**Revised Quarry Restoration Scheme Incorporating
Tunnel Arisings from the Haweswater Aqueduct
Resilience Programme (HARP) Namely the
Bowland and Marl Hill Tunnel Sections.**

Planning Application LCC/2021/0015

Waddington Fell Quarry

Supplemental Submission

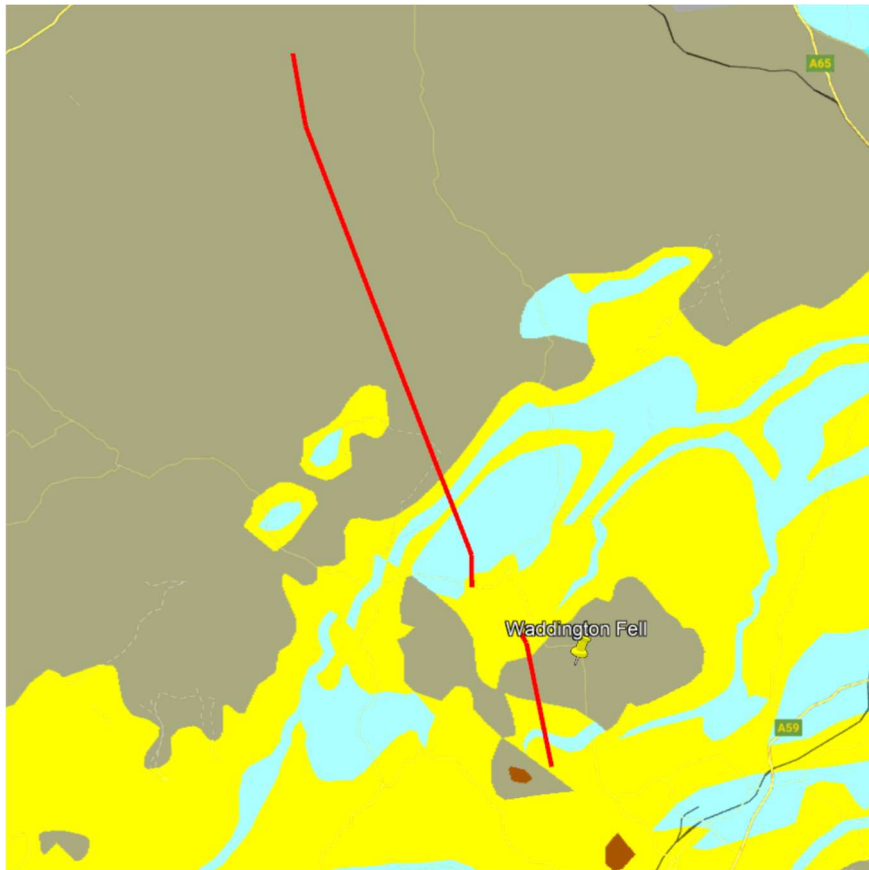
2.15 Environment Team response raised the issue of the suitability of the arisings stating that further information should be provided, specifically:

Further information is required in relation to the nature of the tunnel arisings from the proposed Hawswater Aqueduct. It needs to be demonstrated that any materials that would be used as part of the revised quarry restoration proposals will:

- *be suitable for the establishment of locally appropriate habitats, including moorland habitats typical of the adjoining Biological Heritage Site, such as heathland and acid grassland, and potentially mire communities on areas of impeded drainage.*
- *not affect pH and/or nutrient status of the site in such a way that would be detrimental to the establishment or long-term maintenance of habitats and native plant communities appropriate to the locality (as above).*
- *not encourage colonisation by invasive species or development of inappropriate habitats.*
- *not be in conflict with existing planning obligations associated with the quarry.*

2.16 The material to be used in the restoration works will be excavated rock associated with the HARP construction. The route of the proposed Bowland and Marl Hill length of tunnel pass through bedrock comprising Millstone Grit Group (the same formation worked at Waddington Fell Quarry) comprising mudstone, siltstone and sandstone sedimentary rock, Bowland High Group and Craven Group limestone and Bowland High Group and Craven Group mudstone, siltstone and sandstone.

An extract from the BGS bedrock geology indicates the Millstone Grit Group in light brown, the Bowland High Group in yellow and the Craven Group in blue.

The proposed route of the Bowland section of tunnel is the longer red line to the north of Waddington Fell.

The proposed route of the Marl Hill section of tunnel is identified as the shorter red line.

As can be seen, the majority of the tunnels will run through millstone Grit or sandstone/mudstone which has the same mineral composition as millstone grit.

Appendix 6 – Restoration Drawing 1980/07

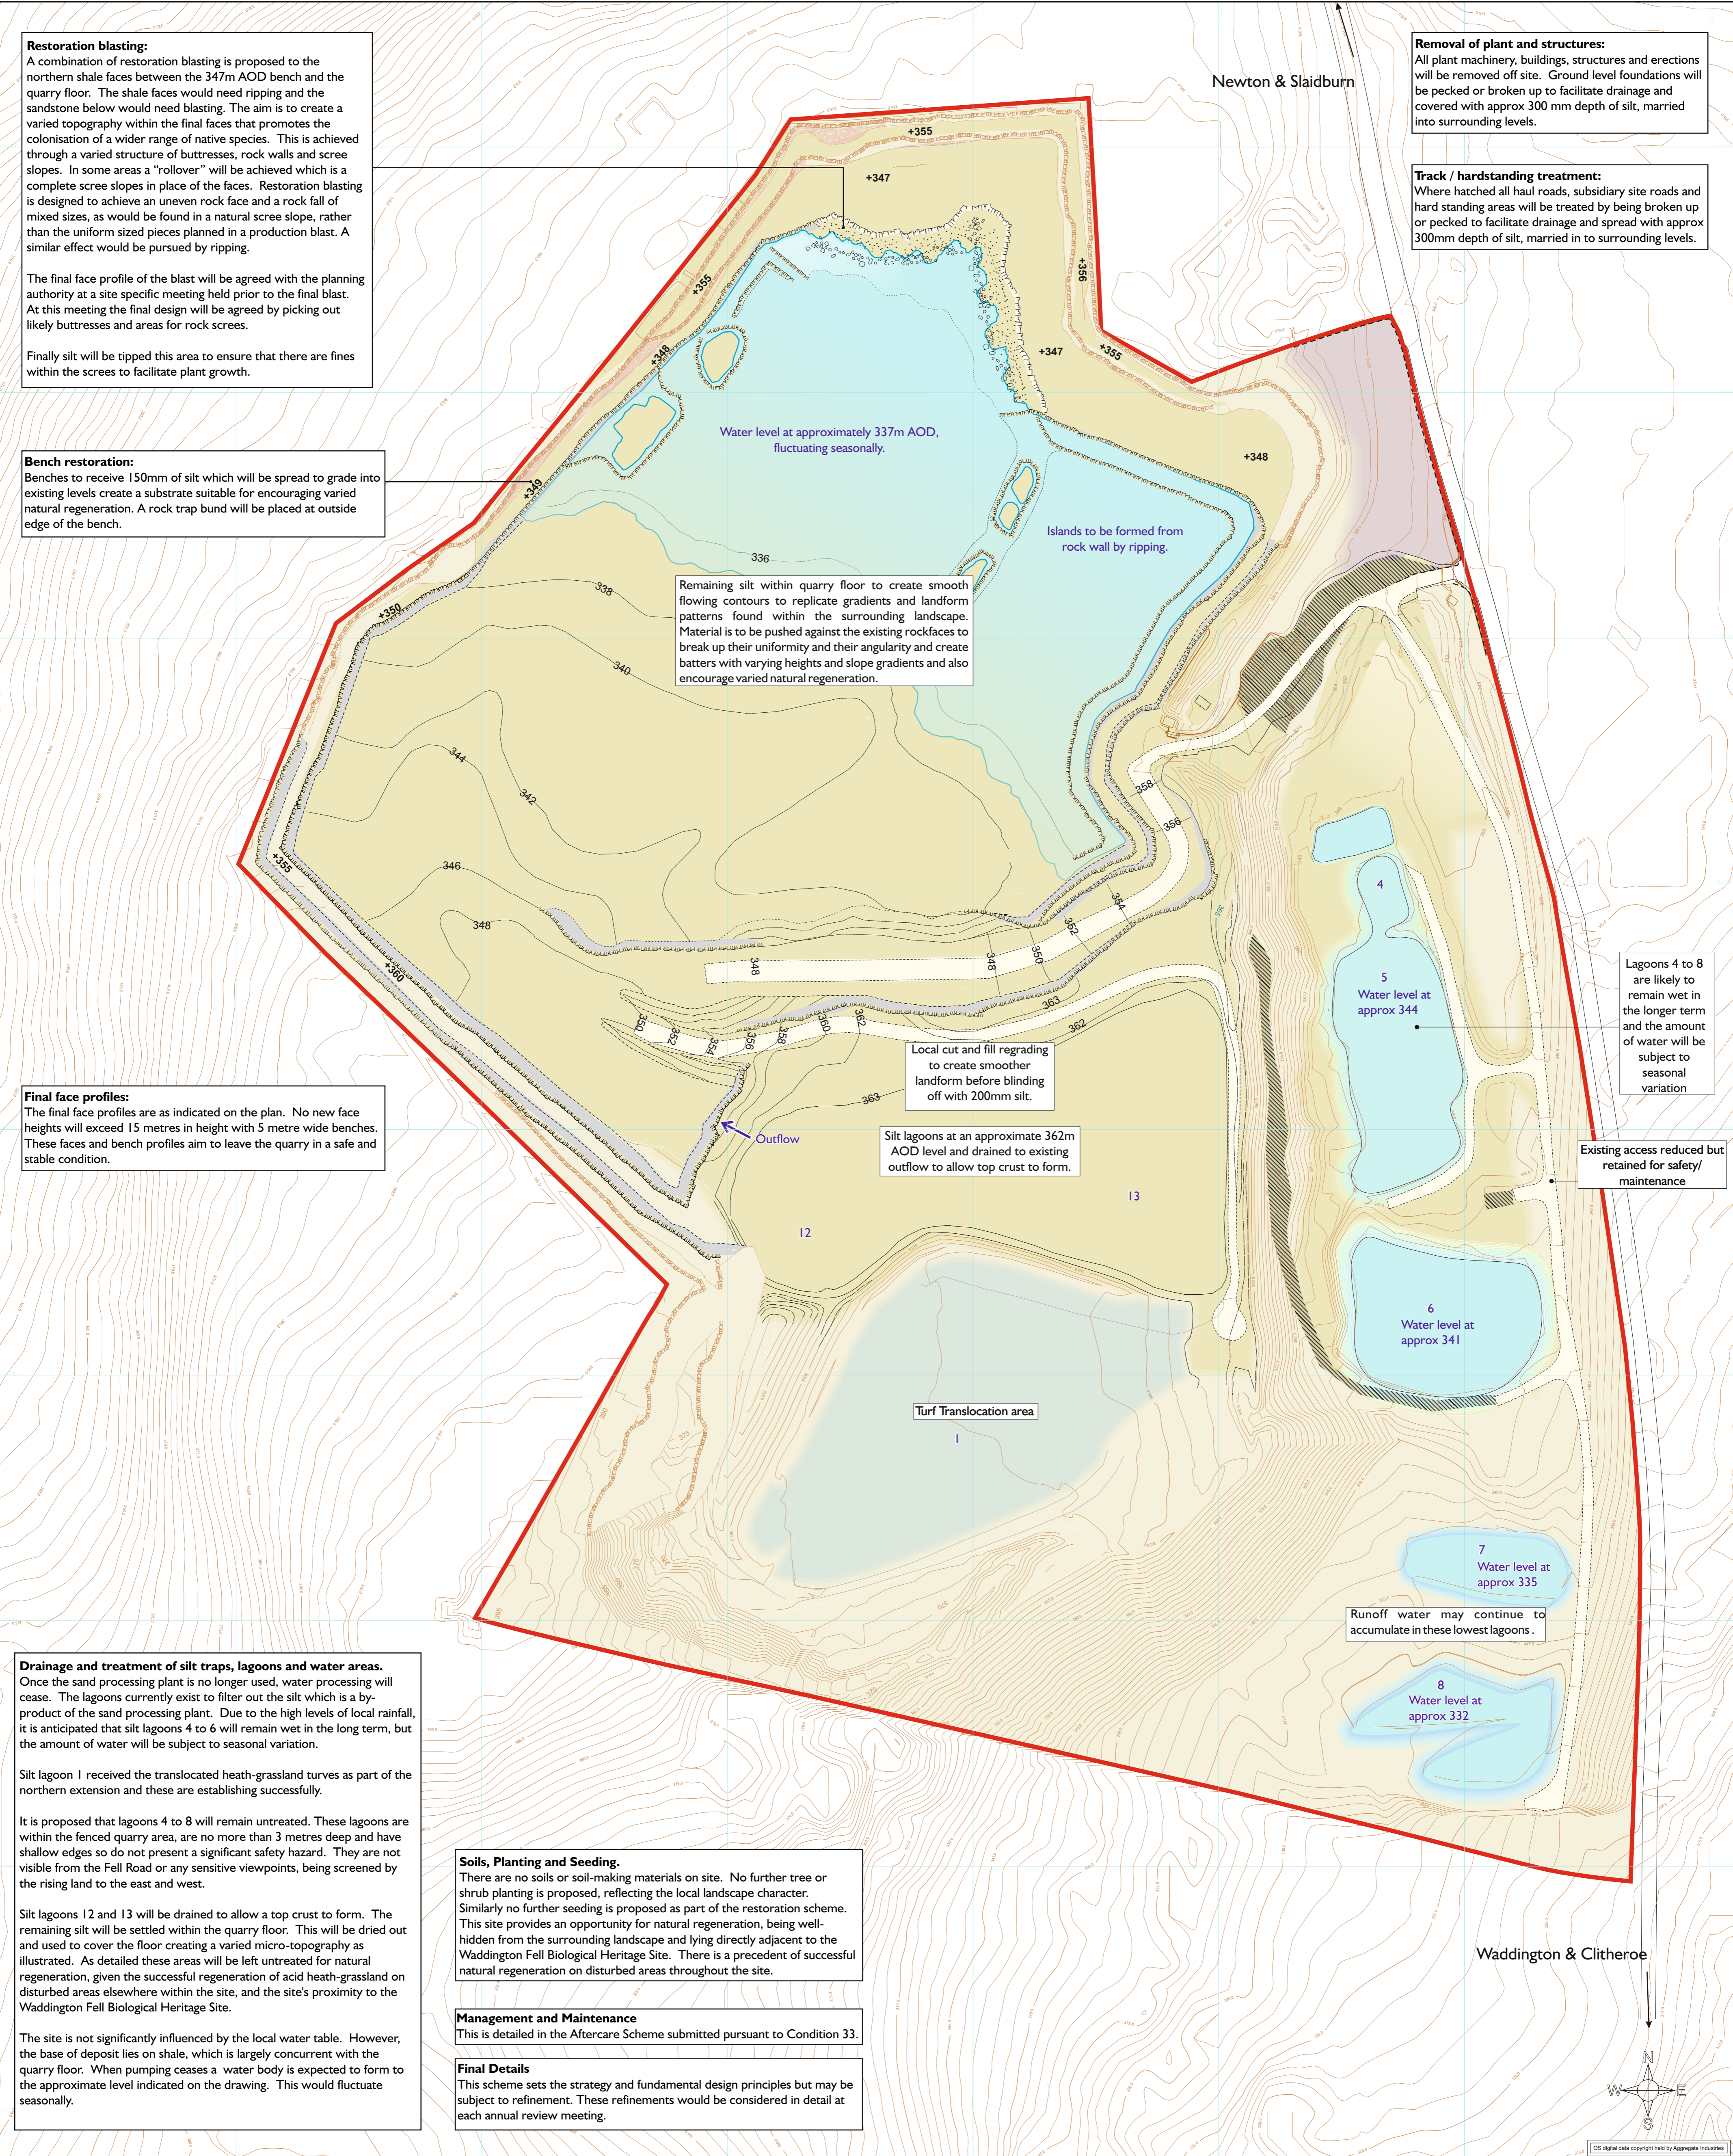
- *Groundwater levels and the source of standing water within the existing quarry must be confirmed, as deposition of material onto sources of groundwater would not be permitted*

- 3.13 The quarry comprises sandstone that sits above a band of shale. The mineral extraction is to the shale deposit. The shale provides an intermediate barrier that prevents surface water from free-draining leading to water collecting in the base of the quarry. This was recognised by the previous operator of the site, Aggregate Industries. In the approved restoration scheme for the quarry (reference 1980/07) dated December 2011 it notes that the level of the water areas would be 'approximately 337m AOD fluctuating seasonally'. The drawing, a copy of which is provided in appendix 6, also confirms that

The site is not significantly influenced by the local water table. However, the base of deposit lies on shale, which is largely concurrent with the quarry floor. When pumping ceases a water body is expected to form to the approximate level indicated on the drawing. This would fluctuate seasonally.
